STAFF REPORT: 09/10/2025 MEETING

ADDRESS: 4000 TYLER

APPLICATION NO: HDC2025-00504

SCOPE: REBUILD BACK PORCH, INSTALL RAILINGS AT FRONT AND BACK PORCH, REPLACE GLASS AT FRONT FAÇADE WINDOWS (WORK COMPLETED WITHOUT APPROVAL)

Current railing. Note height, the oversized/chunky newel posts, and the location of the bottom rail (yellow arrow)

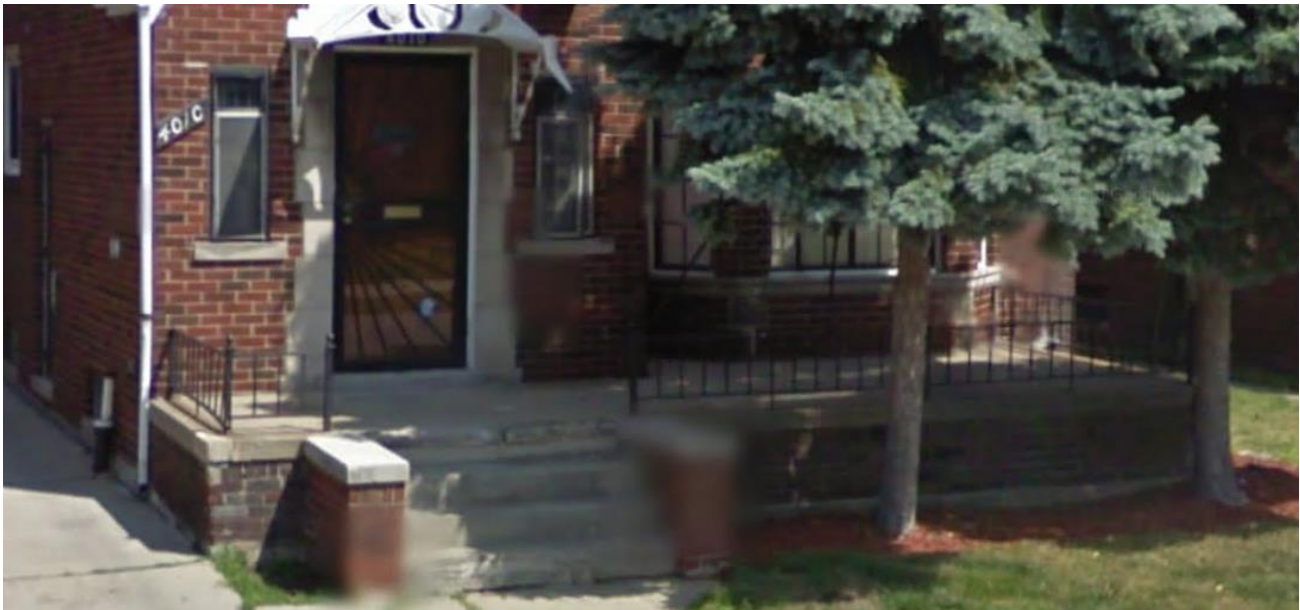
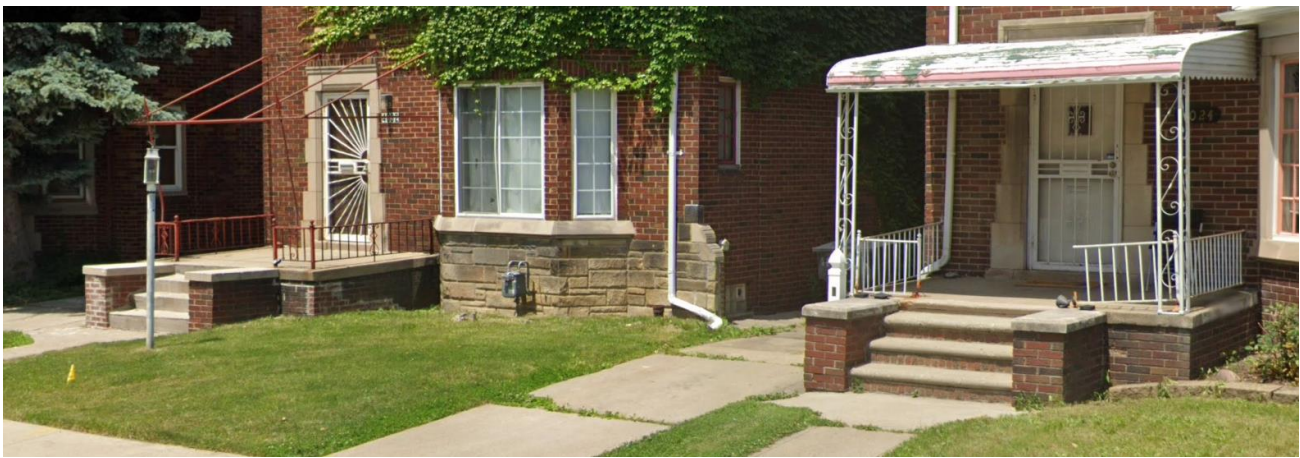
- However, it is staff’s opinion that the railing that has been installed at the front and rear porches is incompatible with the building’s historic character for the following reasons:

- The original railing which was removed without HDC approval sometime between 2009 and 2013 was a low, 24”-inch high metal guardrail with simple square balusters. Also, see the below Google Streetview images of houses directly next to and across the street from the subject property to note that they have simple, low, metal railings. The front and rear porch railings that were installed at 4000 Tyler without approval are inappropriately high and of an incompatible design to include the integrated light fixture and prominent newel posts (see below photos). Staff also notes that the lack of wingwalls at the stairs and the location of the bottom sub-rail on the outside of the stairs contribute to the discordant appearance of the new railing.

Original railing. Note the low height and simple design and wingwall (red arrows)

Houses next to and across the street from 4000 Tyler. Note style, material, and height of the guard railing. Also, note the presence of the wingwalls that flank the stairs

- The historic character-defining railing at the front porch was a low, 24"-inch high metal guardrail with simple square balusters that were integrated in between/into the top and bottom rail. The current railing at the front and rear porches does not adequately match the historic as it is inappropriately high and displays an incompatible design to include integrated light fixtures, prominent newel posts, and face-mounted balusters. Also, metal is a better match to the original railing at the front porch that was removed without approval and is more compatible with the material that is commonly used for railings within the historic district.

Current railing design (at front and back porch). Note that the balusters have been applied to the outside of the top and bottom rails (see red arrow).

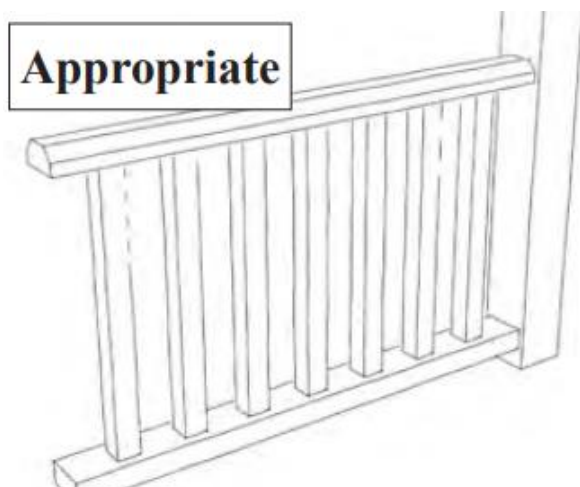
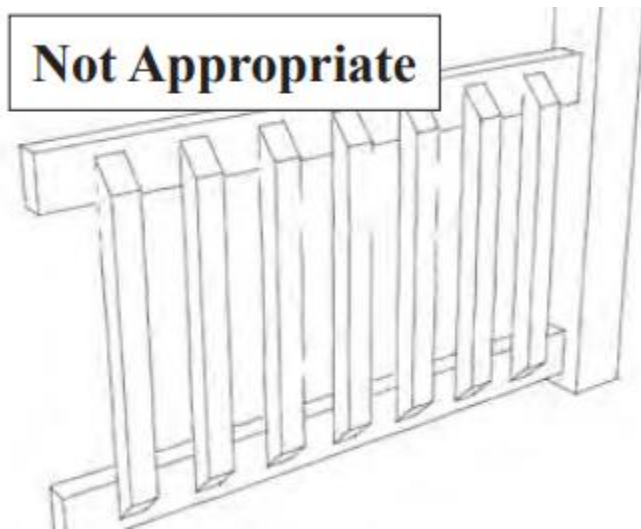
- Also, historic porch railing typically consists of balusters which are integrated into the top and bottom rails (see below graphic). The railings which were installed at the front and rear porches at 4000 Tyler have face mounted balusters, ie, the balusters have been attached to the outside of the bottom and top rails (see the below graphic and photo). Note that it is staff's opinion that face mounted railing systems are only appropriate for modern rear yard decks that represent a contemporary addition to a house and are not visible from the public right-of-way.

Historic porch railing. Note that the balusters are located between the top and bottom rails.

Railing that is typically installed at modern rear decks. Note that the balusters have been applied to the outer surface of the top and bottom rails. This type of railing is not appropriate for installation at porches in historic districts

Conditions in May 2025, fixed windows that flank the front door. Note that the window to the right appears to be in poor condition while the window on the left appears to be in good condition. Photo by HDC staff

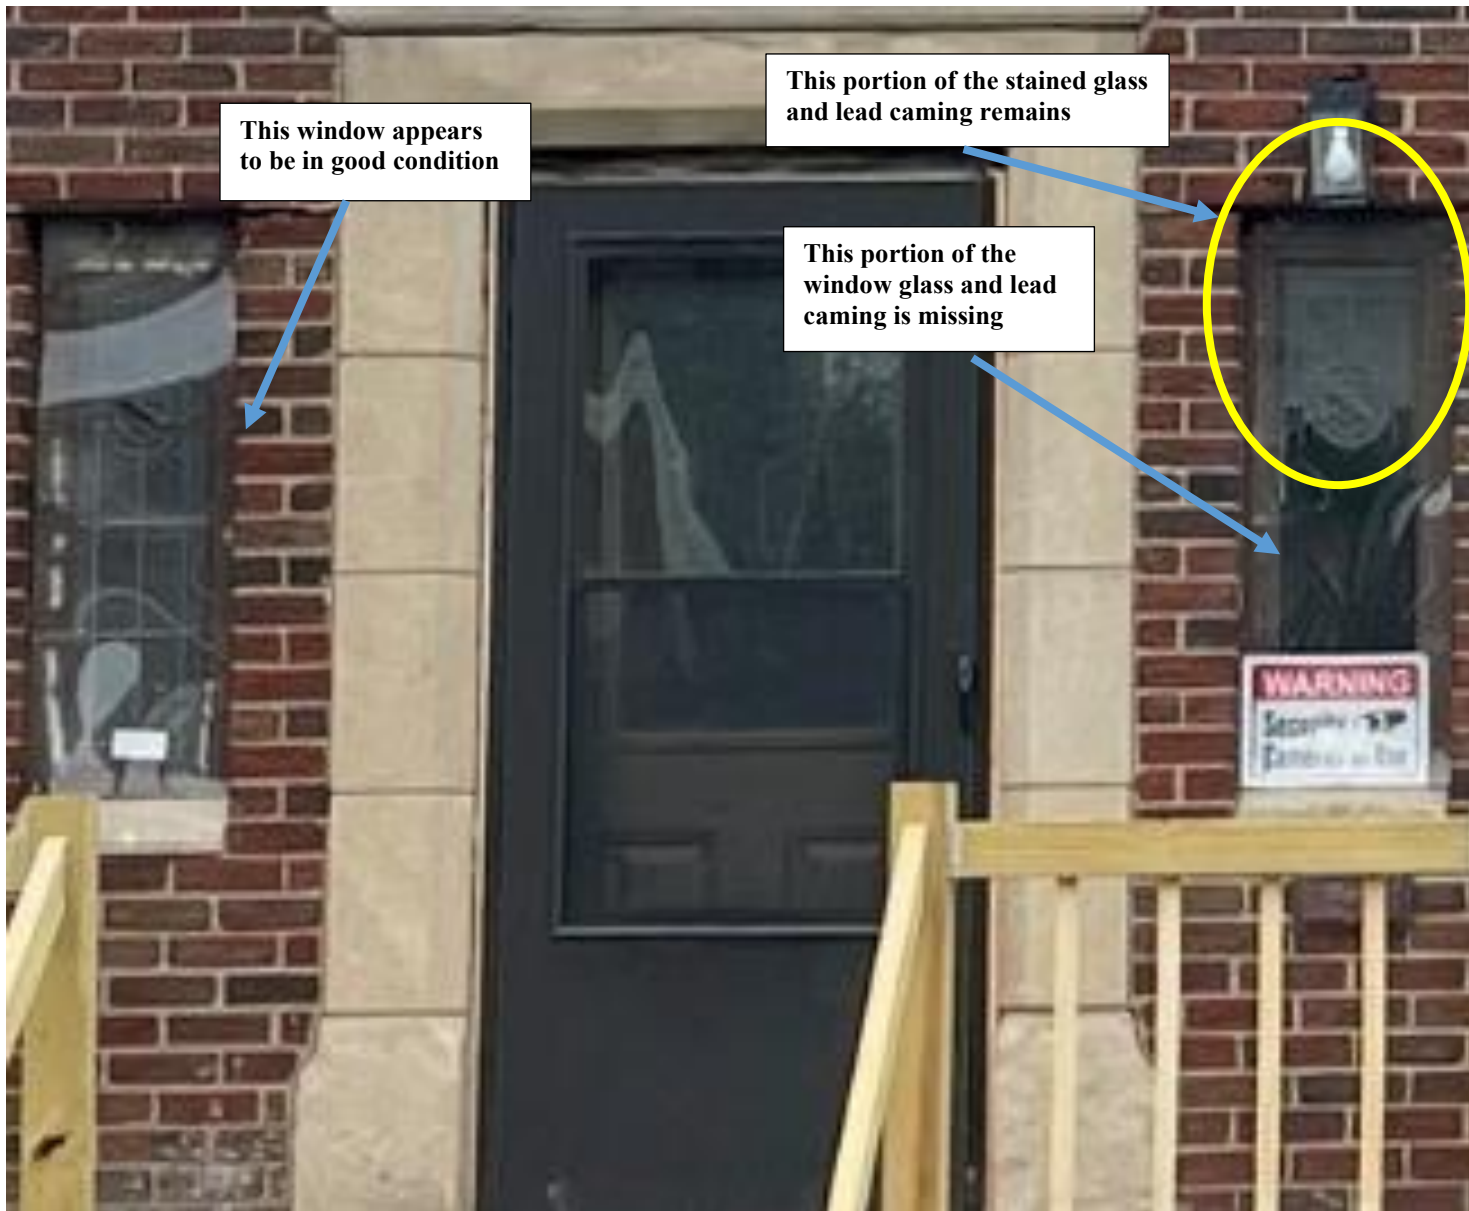
- As previously noted, the 2019 COA only allowed for the replacement of broken glass at the windows. A review of photos of the property taken in May 2025 indicates that one of the two windows which flank the front door and all of the windows at the transom at the front façade

bay appeared to be in good condition (see the below photos). However, while the lead coming and glass at the second window that flanks the front door was partially missing in May 2025, the decorative stained glass and lead coming above was still present. Staff notes that the 2019 COA covered the replacement of broken glass at the windows. Therefore, the recent replacement of the lead coming and stained glass that was present in May 2025 does *not* conform to the 2019 COA as the elements were not broken. It is staff's opinion that the recent removal of the distinctive, character-defining stained glass and lead coming at windows that remained in May 2025 does not meet the Standards. Also, the clear glass which replaced these decorative, distinctive elements is not an adequate match.

Conditions in May 2025, front façade bay. Note that the decorative transom windows appear to be in good condition.
Photo by HDC staff

- The current application did not adequately demonstrate that the distinctive, character-defining, stained glass and lead coming that was located at the front façade bay's transom and at one window to the side of the front door was deteriorated beyond repair. Additionally, the clear glass which replaced these distinctive decorative elements is not an adequate match.
